Details of Additions & Alterations

| Flat No    | A-314               | Type  | Deluxe / Semi-Deluxe        |

THIR  
BRICK WORK DETAILS  
TYPE V  
FLAT NO: 14, 15 & 16

PROPOSED RESIDENTIAL APARTMENT  
FOR MODI PROPERTIES AT KOWKUR, HYD.

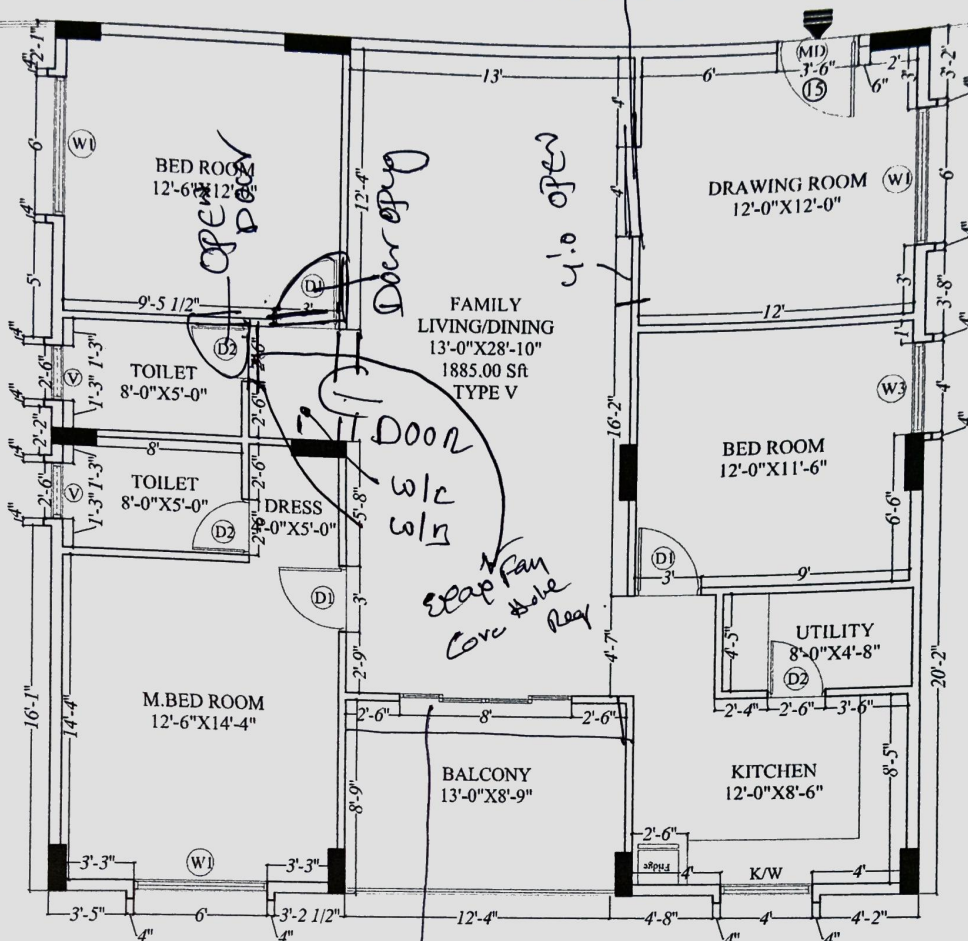
K.B, G.B, Drawing, Dining, - williams grey  
m.B & Balcony - urban wood  
dark  
utility - country Almond  
floor

Powder Room - Malaniyam Brown  
M.T G.K.T - Luna Series.  
Bed.

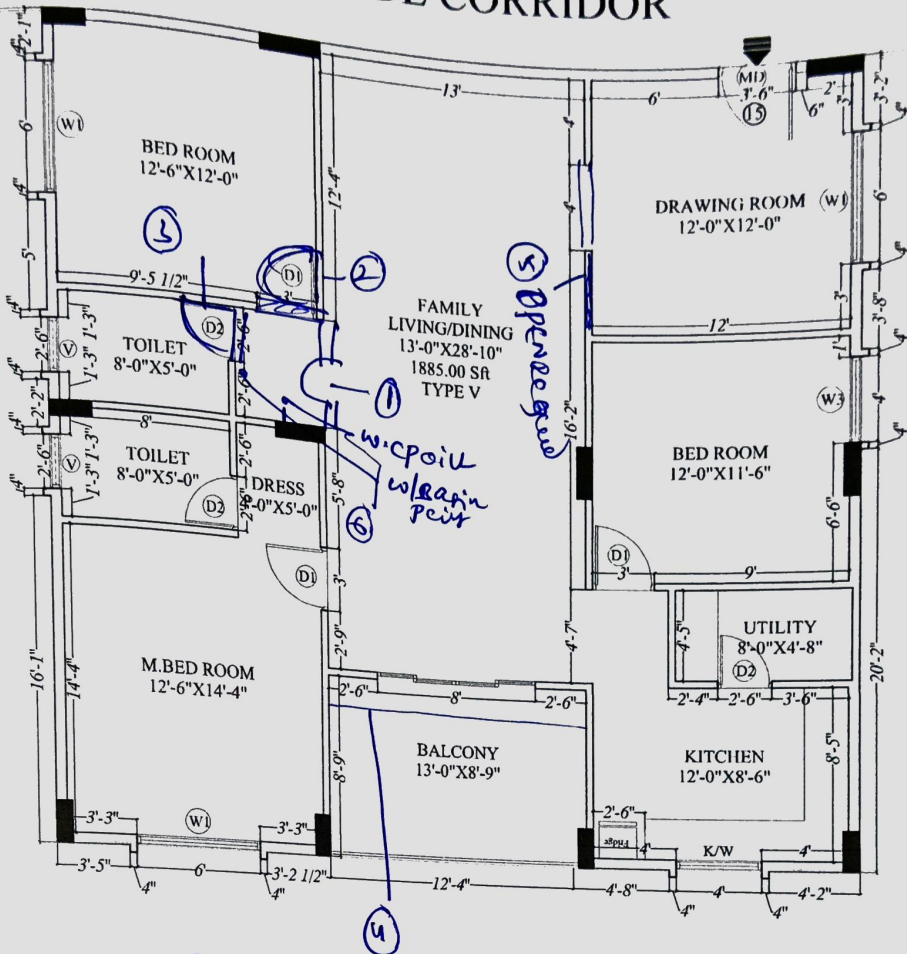
⑤ Drawing hall opening required towards c.l.d.

- ⑥ ① Guest Dress area in side extra w.c. & w/b provision required.
- ② Guest Bed room opening required in the Hall side
- ③ C/toilet opening required in side of the c.l.d. room
- ④ Sit out reduced 7'10" instead of 8'9"
